Contract No. HK/2009/01

Wan Chai Development Phase II – Central -Wan Chai Bypass at
Hong Kong Convention and Exhibition Centre

Silt Screen Deployment Plan

Appendix A
Location Plan for Type 1 to 3 Silt Screen

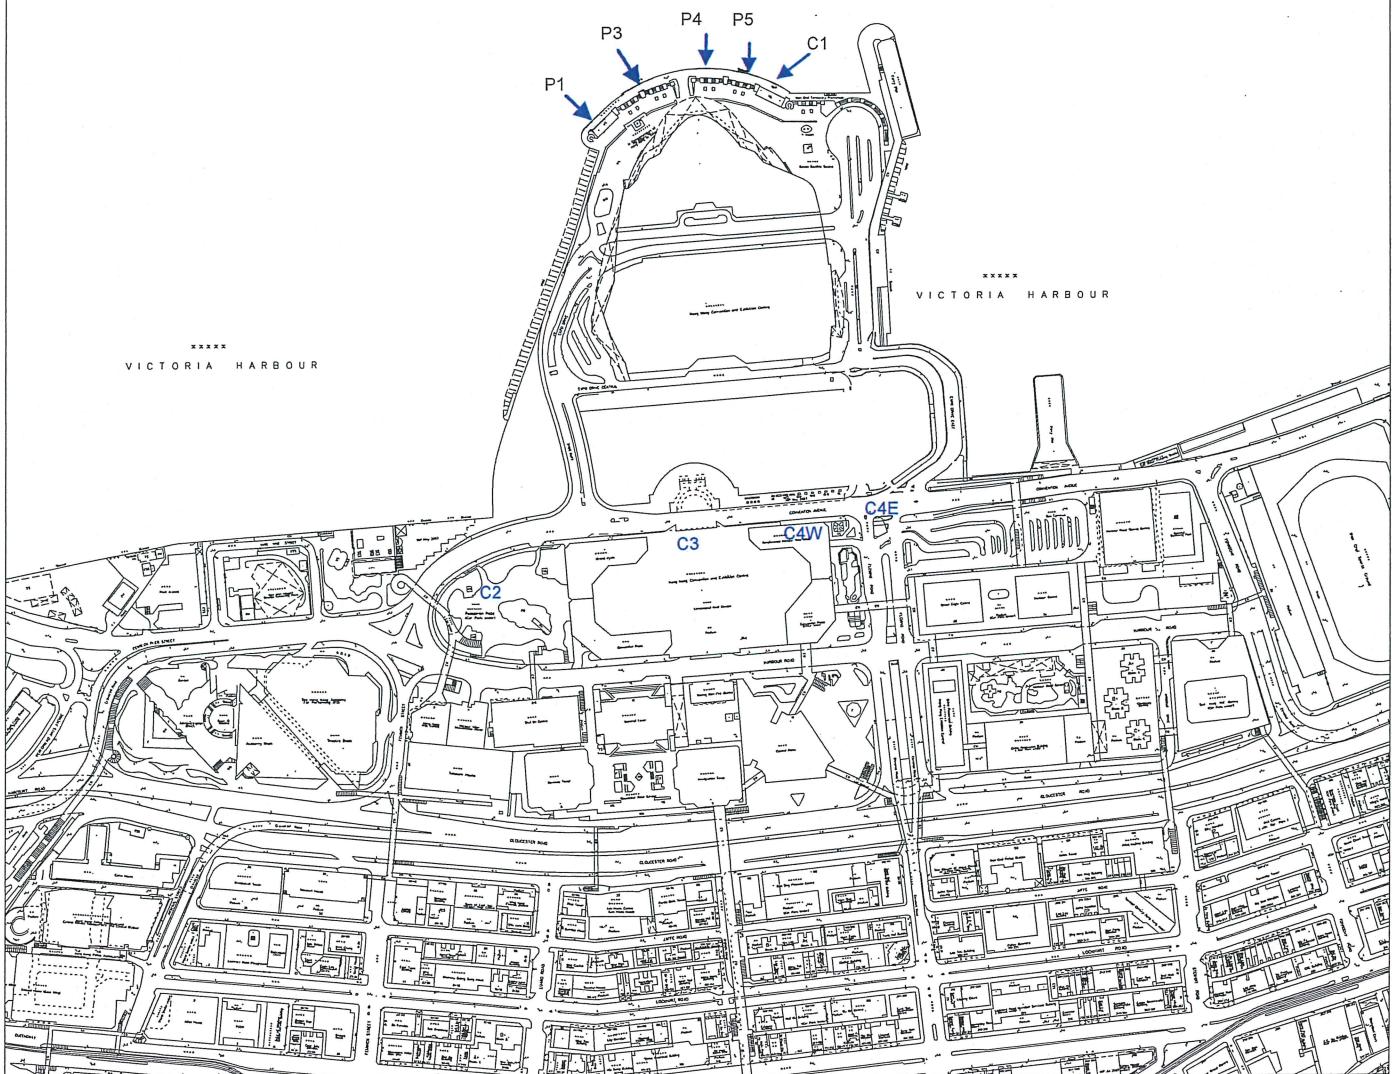
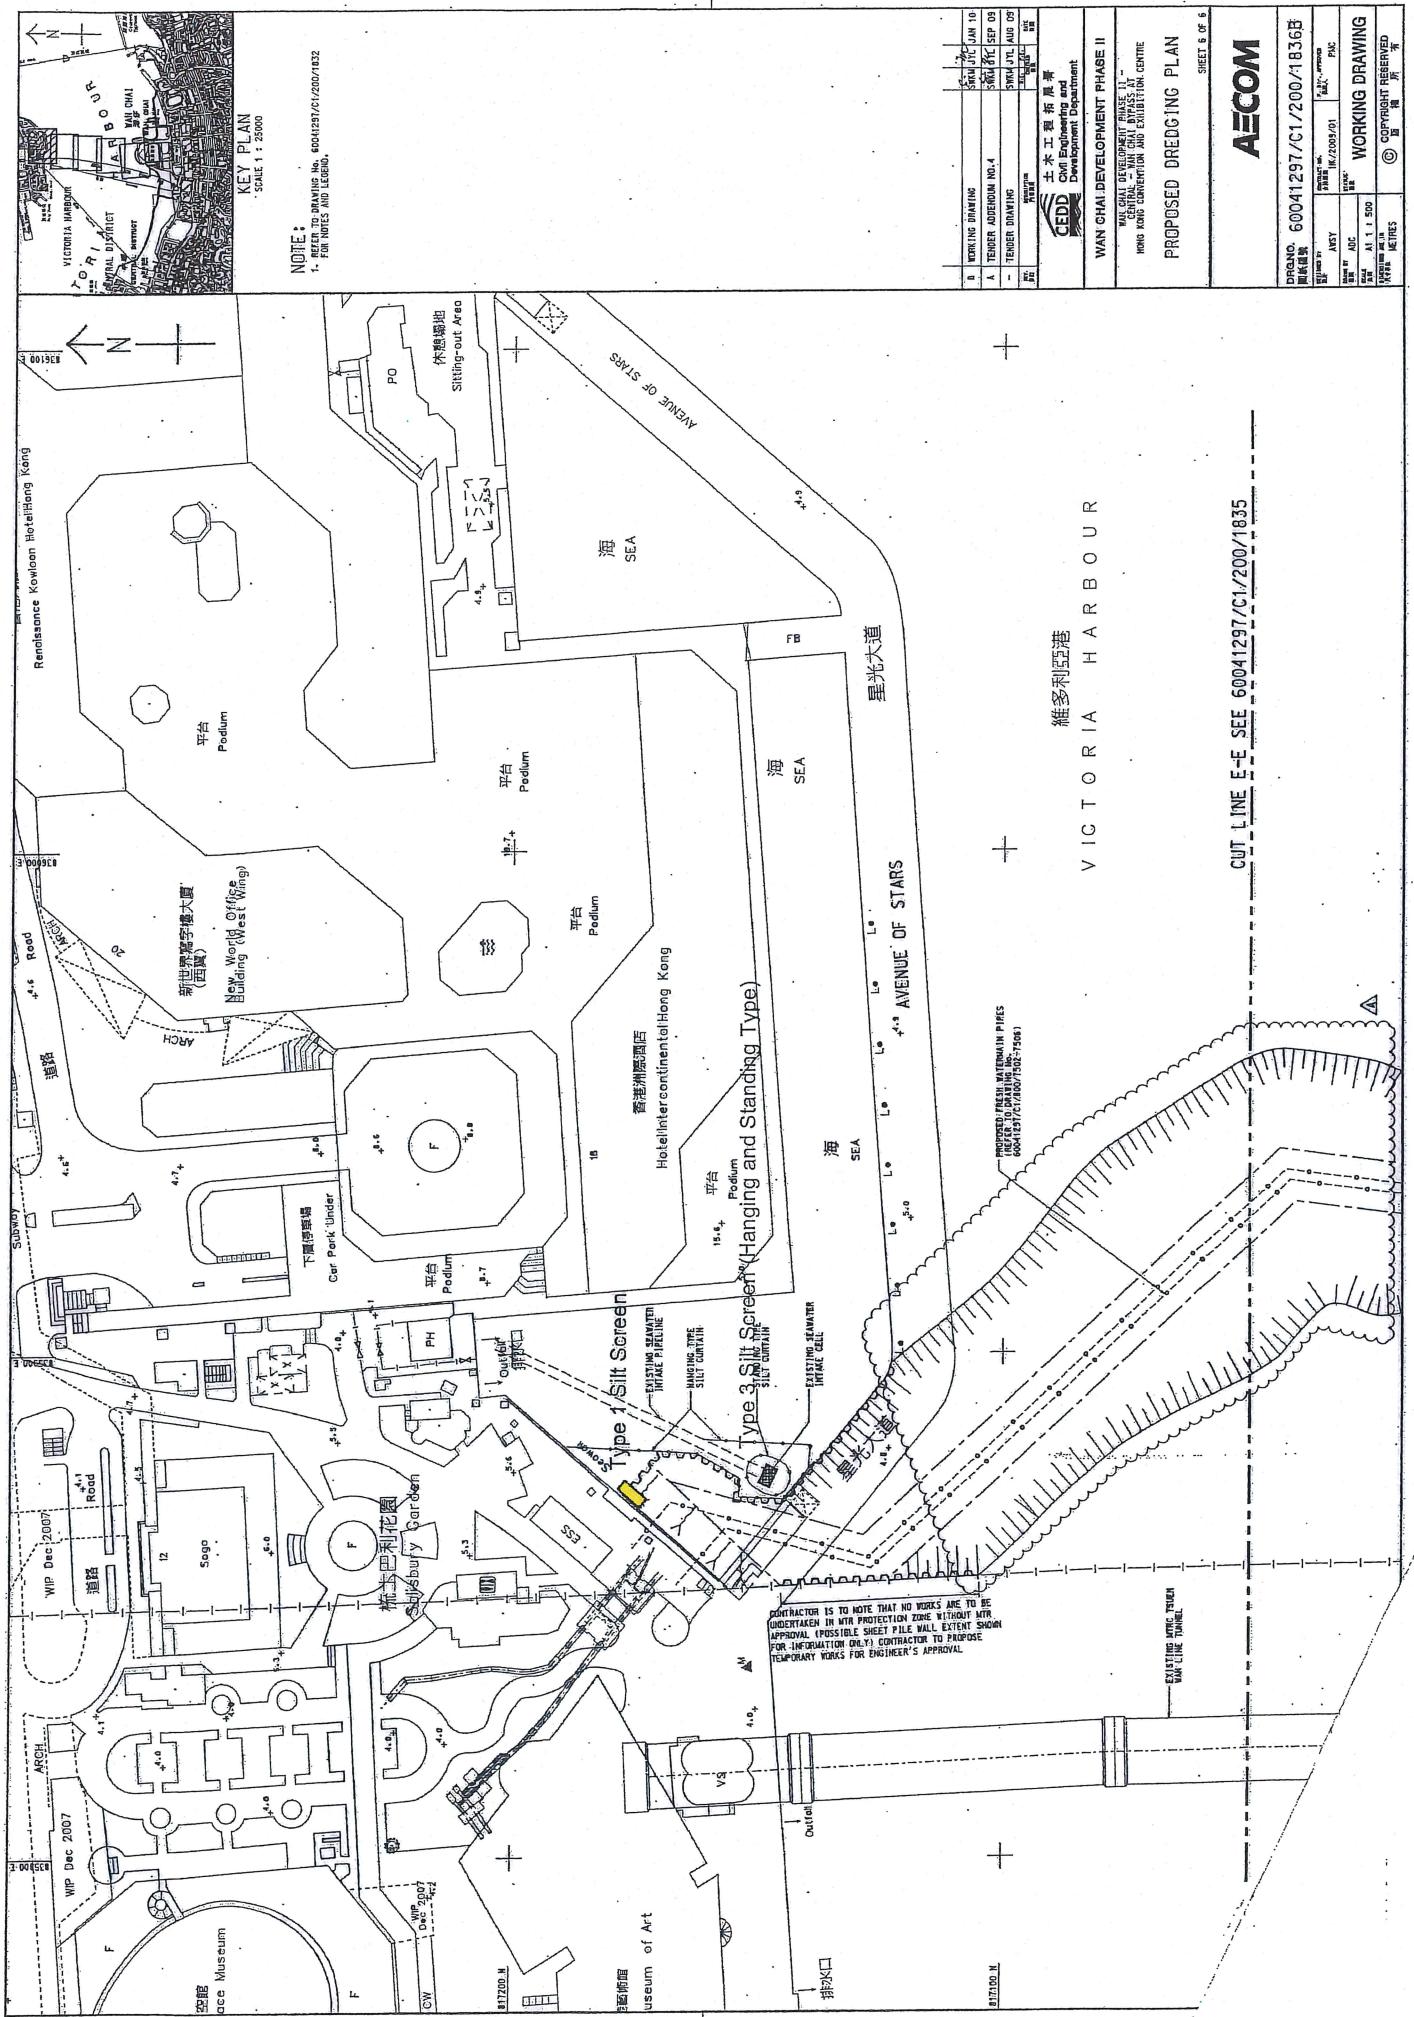
- (1) Some figures and texts in the appendixes (e.g. App.A - Location Plan; App.F - Arrangement of Access Provision for Water Monitoring, etc) are so blurred and not easy to read, please provide figures with higher resolution;
- (2) Please add a paragraph to outline why amendment of plan is necessary at, say section 1.1 Introduction, to facilitate the general reader to follow the logic; and
- (3) Please review the submission to ensure the general fluency and to prevent minor grammatical mistakes.
